Built Heritage Sub-Committee / Sous-comité du patrimoine bâti
February 11, 2020 / 11 février 2020

File Number: ACS2020-PIE-RHU-0005

SUBJECT: Application to Alter two heritage properties, 35-37 William Street and 41-41 1/2 William Street, designated under Part V of the *Ontario Heritage Act* and located in the ByWard Market Heritage Conservation District, according to plans by KWC Architects, received in December 2019

Document 7 – Elevations, 35-37 William Street

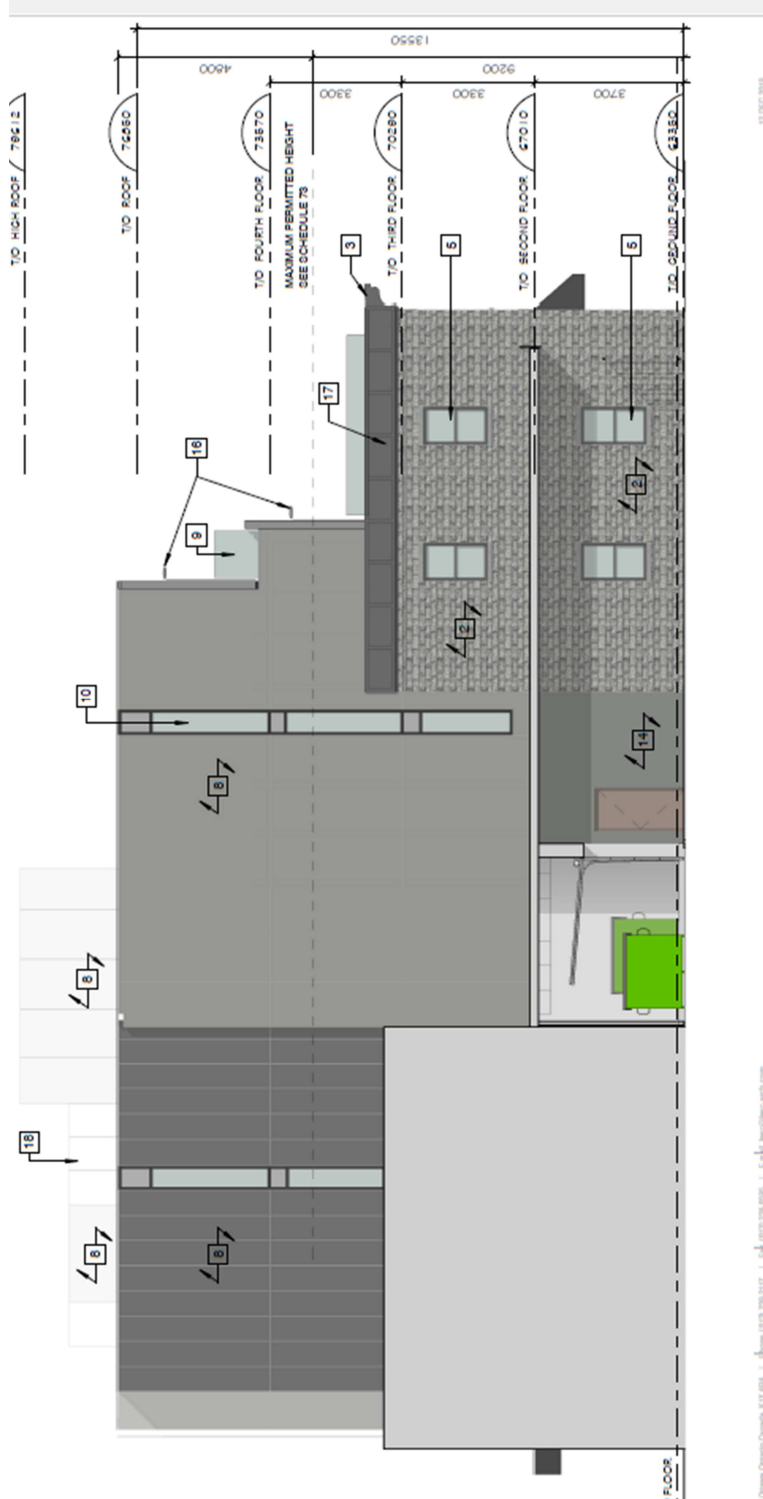
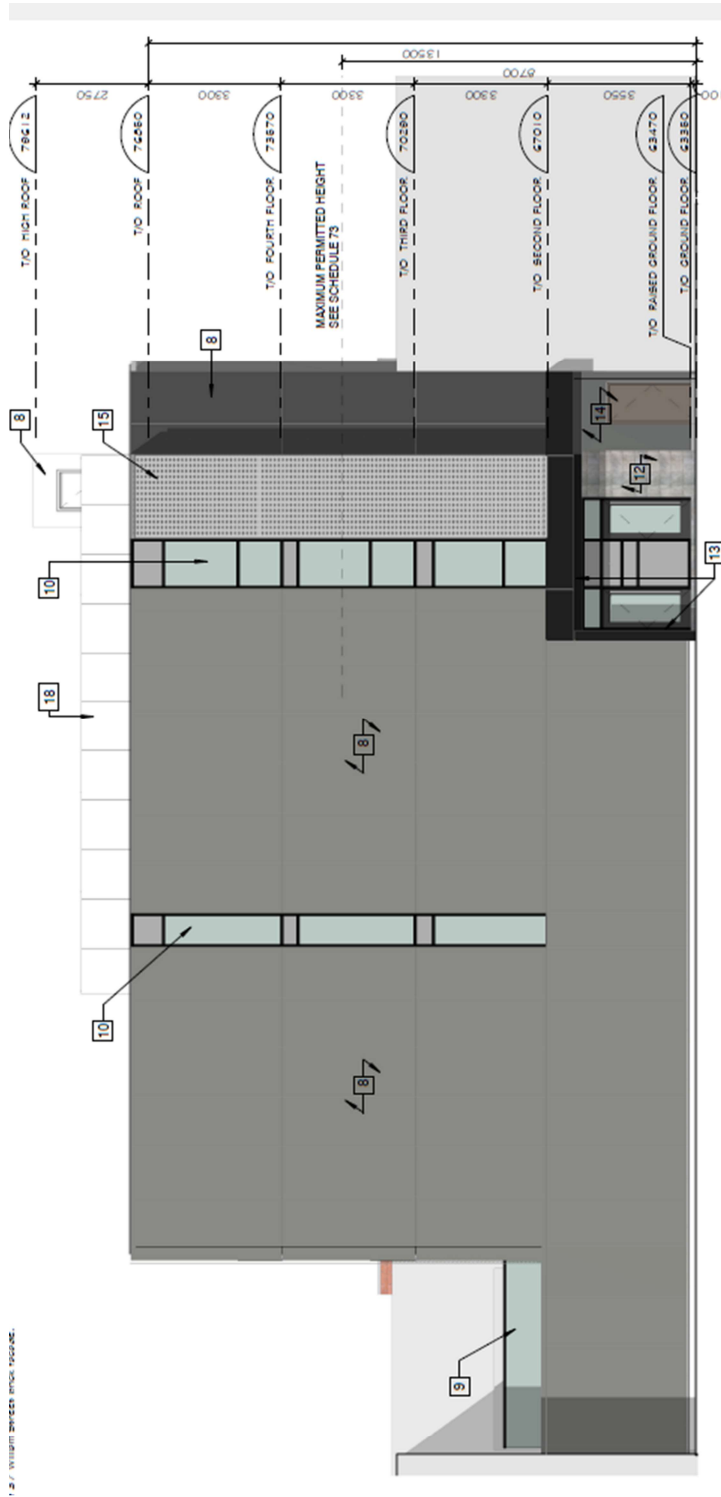
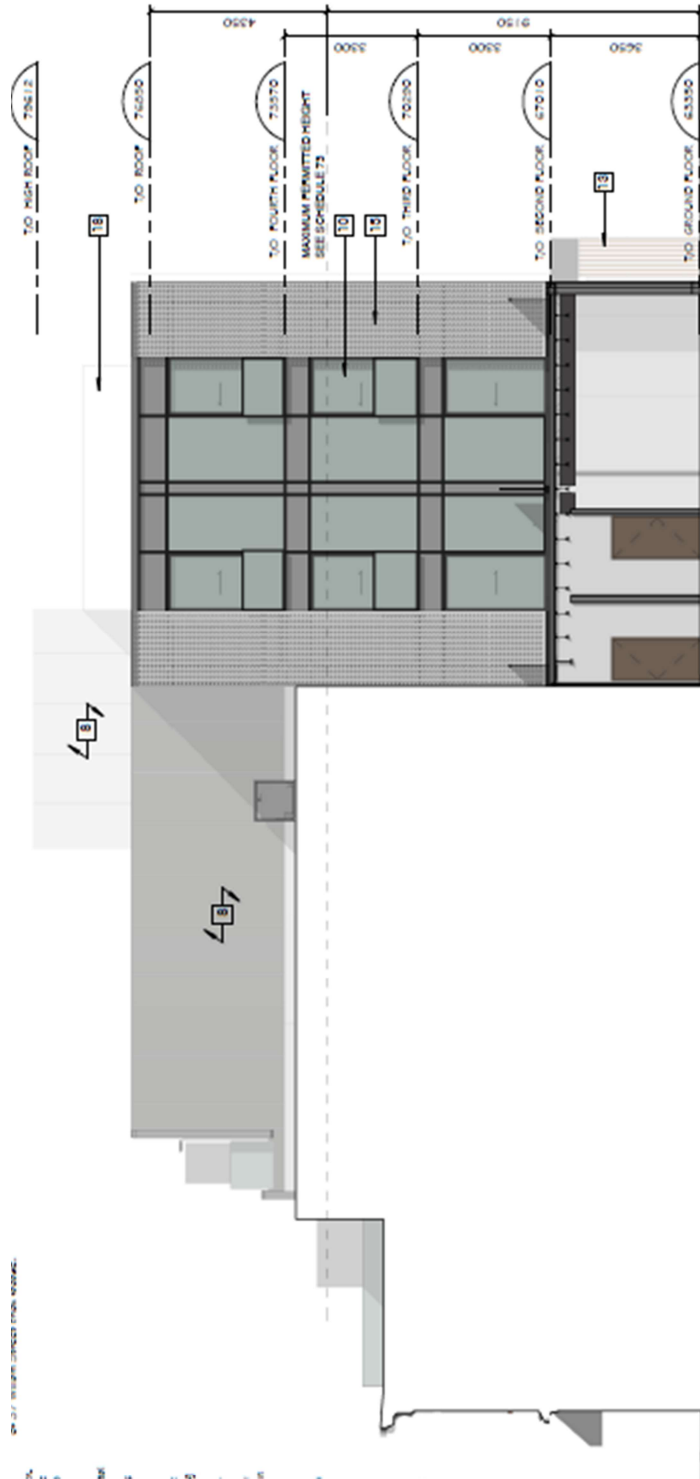
"I am supportive of the proposal for the alteration of the fire-damaged buildings, 35-37 William Street. I am happy to see the project moving forward, and, with respect to the heritage and the character of the ByWard Market. With regard to specific plans, I would

like to see some added visual relief to the windowless walls (facing east and west) as well as set back the proposed balcony railing on the third floor from the William Street façade.

Additionally, I would like to add windows on the first floor of the east façade, to break up the hard surface and add light, this could be in the form of high horizontal windows. I would also like to ensure roof-top projections are located in a spot to minimize impact to the streetscape and add some kind of detail in design to add a visual interest to the large, blank wall on the west facing wall.”
